# Office of Highway Safety

## Road Safety Audit Review

<b>Town:</b>	Marshfield	<b>Date Reviewed:</b>	August 22, 2017
<b>Route:</b>	VT 215 (Cabot Road)	<b>Mile points:</b>	VT 215 MM 0.0 – 0.26

# Appendix A, Proposed Signage

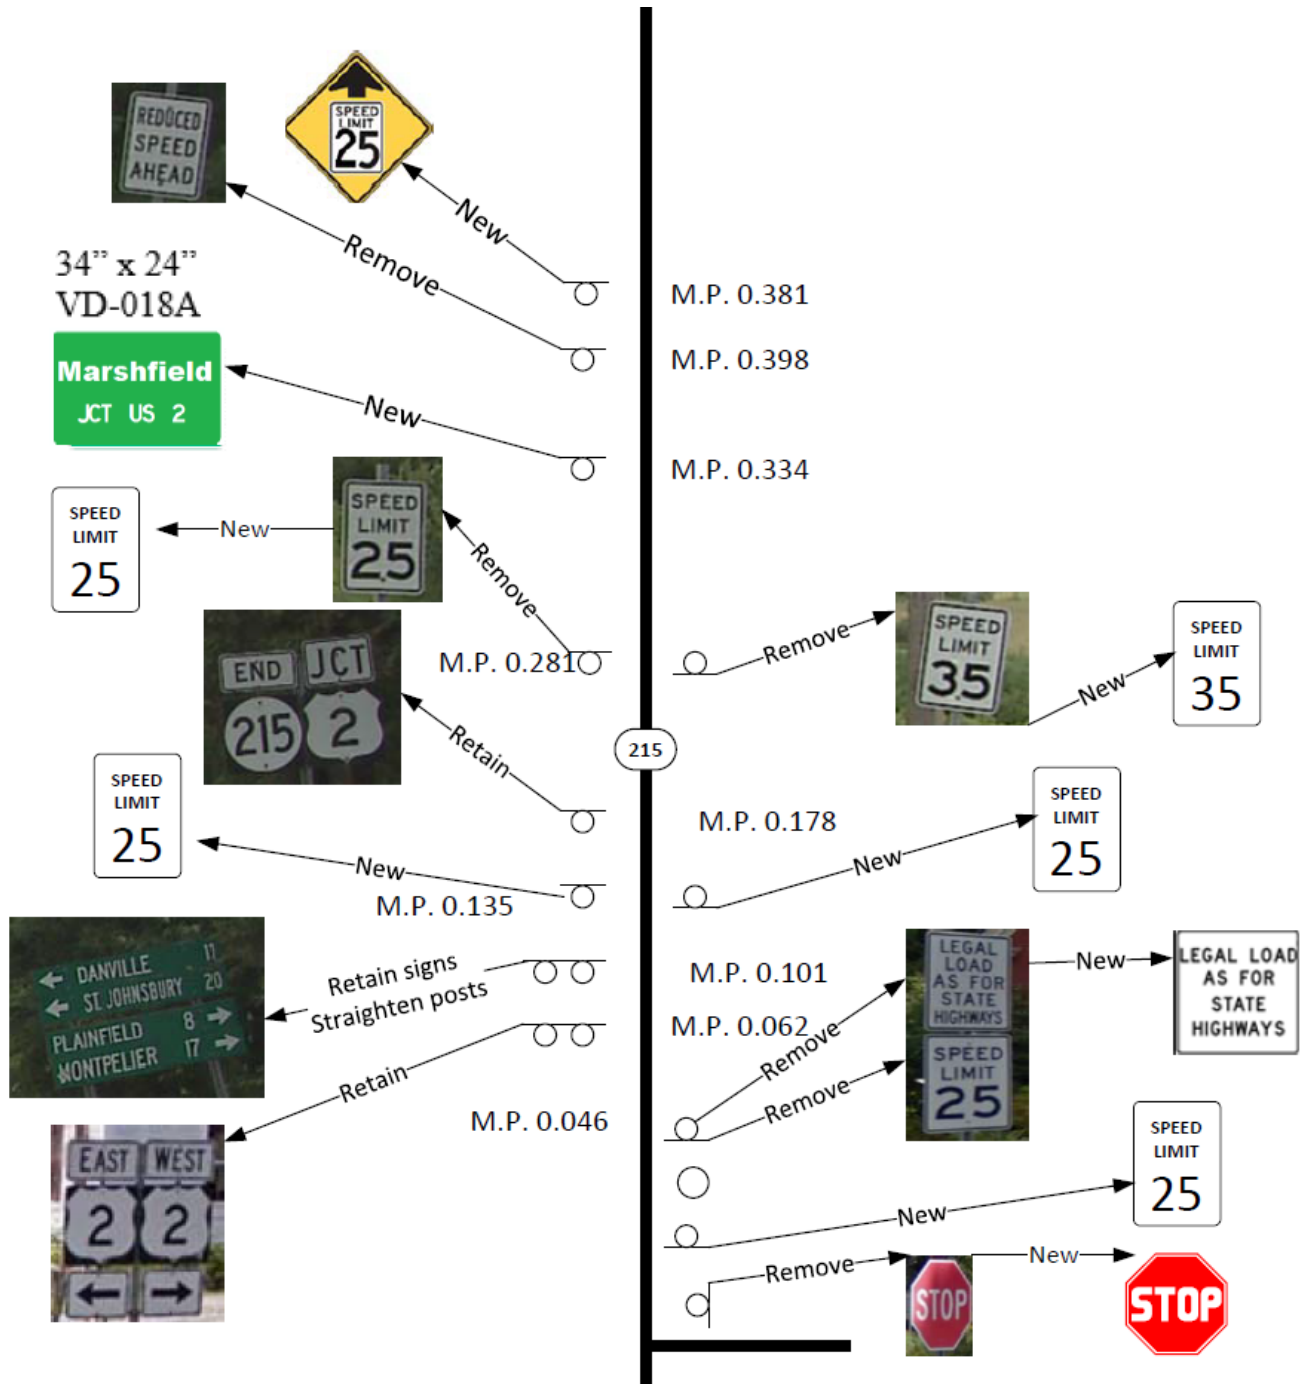
Revised signage southbound to create a gateway feel and indicate to motorists that they are approaching a village area<sup>2</sup>.

## Appendix B, Potential New Speed Limit Scheme

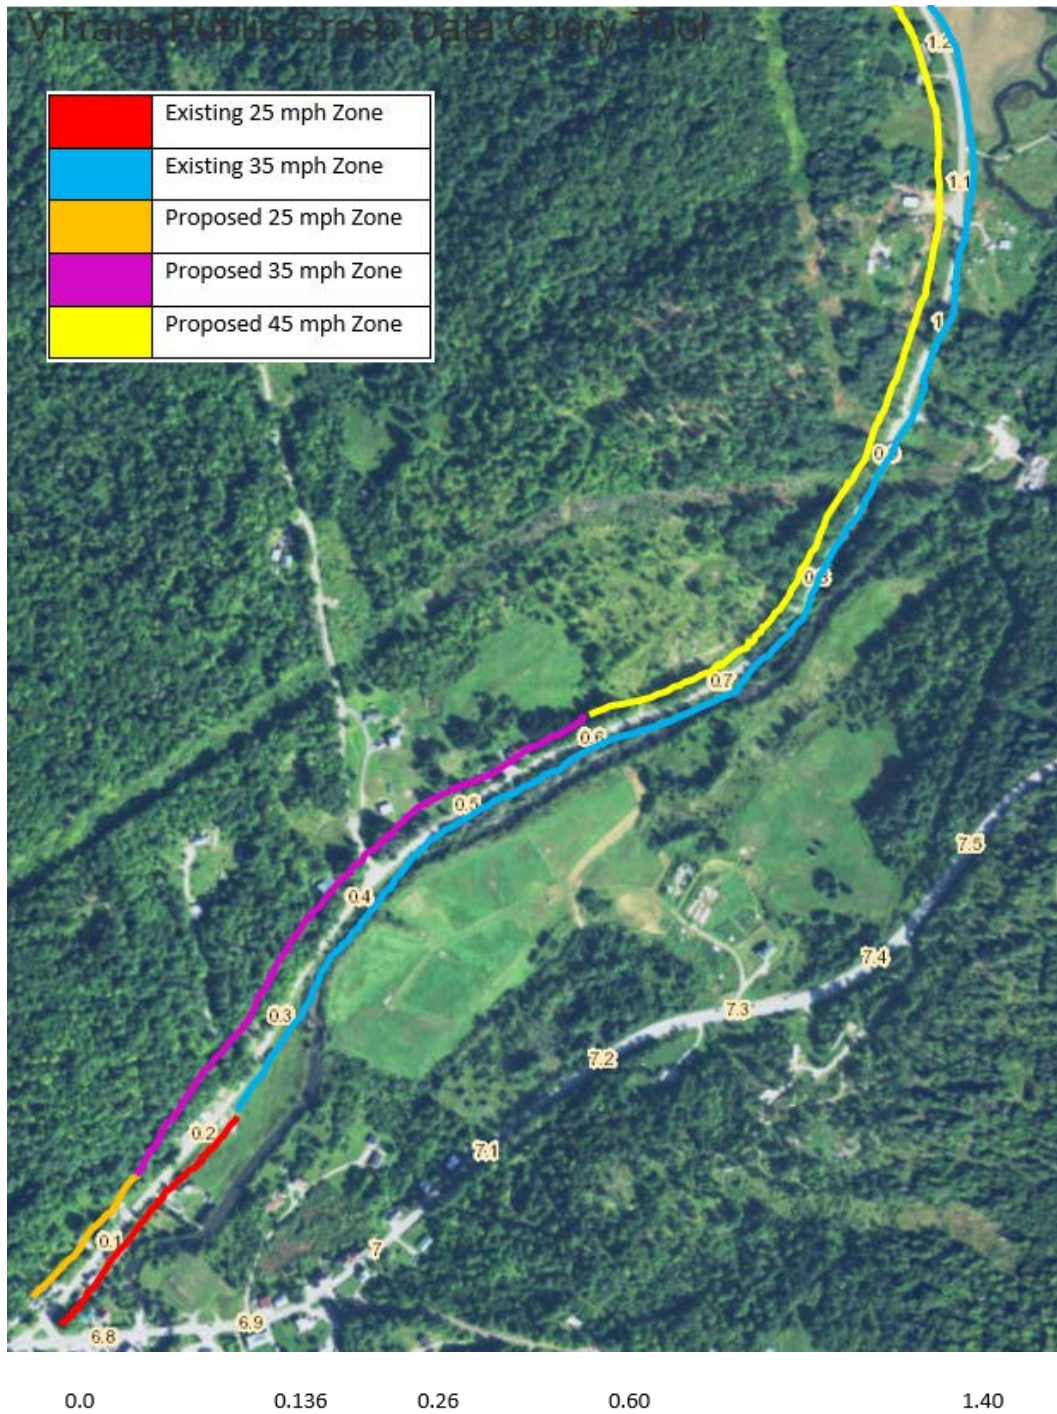
Consider reviewing the speed limit along the entire length of VT 215 to provide reasonably enforceable speed limits. See Appendix B for a proposed scheme.

Existing 25 mph		Existing 35 MPH	
New 25 mph	New 35 mph		New 45 mph
From intersection of US 2 to a 720 feet northward (mile point 0.0 to 0.136)	From mile point 0.136 to about 0.60		From 0.60 to Cabot Townline
